State of Idaho
DEPARTMENT OF WATER RESOURCES
322 East Front Street • P.O. Box 83720 • Boise, Idaho 83720-0098
Phone: (208) 287-4800 • Fax: (208) 287-6700 • Web Site: www.idwr.idaho.gov

**RE: Big Bend Ditch Broad Crested Weir Measurement Device**

**RE: Field evaluation of Big Bend Ditch Broad Crested Weir Measurement Device**

# BIG BEND IRR. DITCH BCW FIELD MEASUREMENTS

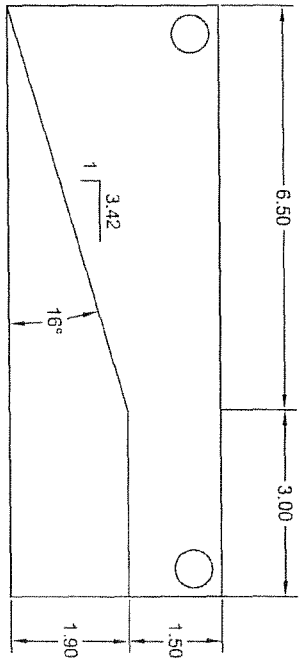
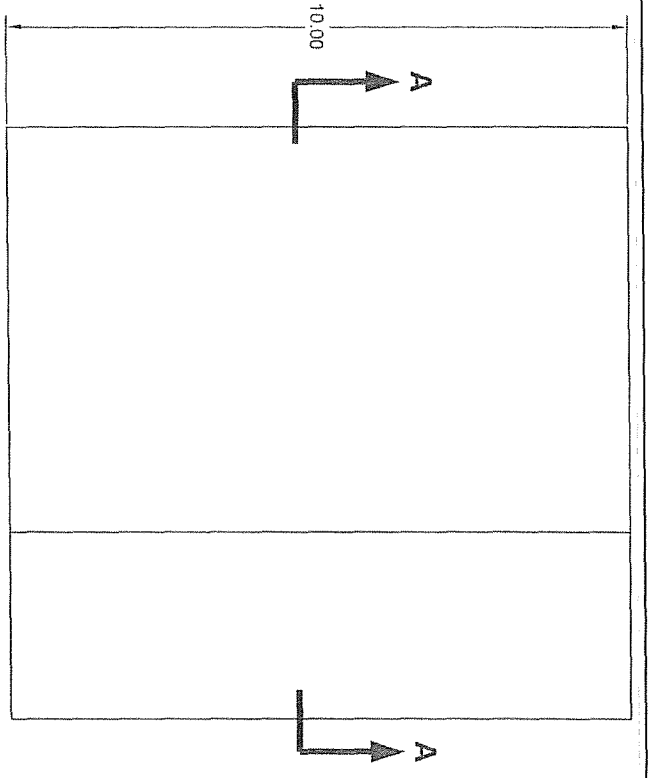
In addition, during the site visit we collected field measurements of the as-built conditions of the BCW, which included a width of 10.00 feet, a sill length of 3.00 feet, a sill height of 1.90 feet, and a ramp convergence length of 6.50 feet. Refer to the attached sketch of the BCW and the observed as-built dimensions. The width of the concrete channel upstream of the BCW was measured at 10.50 feet. The following observations were also made which likely affect the accuracy and operability of the device to an unspecified degree.

- Sediment and matted vegetative material with a depth of 3-4 inches observed at toe of weir.
- The high water line indicates high flow water in the channel overtops lateral structural supports.
- Observed gaps between the outside edges of the BCW and the channel walls of ~3-inches.

Based upon the findings of the site visit I analyzed the adequacy of the device for measuring flows using WinFlume32.[1] My analysis indicates that as the BCW was built, there is a fatal flaw in the dimensions of the device that do not allow for the accurate measurement of water in the channel. This is due to the inability of the device to establish critical flow over the sill at flows in excess of 23.2 cfs. Refer to attached 'Summary of Evaluation of Flume Design' for complete analysis summary (2 pages).[2]

Assuming a width of 10.00 feet, a ramp convergence length of 7.25 feet, and a sill length of 3.00 feet, a sill height of 2.9 feet would be required to measure the flows observed during the site visit (39.8 cfs) with an accuracy of 10.0% or less. This would result in an upstream water surface elevation of approximately 4.1 feet, which provides a freeboard of approximately -0.1 feet over the existing top of channel wall. Refer to attached 'Summary of Evaluation of Flume Design' for complete analysis summary (2 pages).[3]

In my limited time evaluating the matter I was unable to come up with a BCW configuration that does not lead to the overtopping of the existing channel walls at the measured flow rate. However, other measurement devices are feasible for the channel as it is currently constructed. I have preliminarily identified three possible measurement options and I would recommend pursing one of the following courses of action in developing a means of accurately and reliably measuring flows in the ditch.
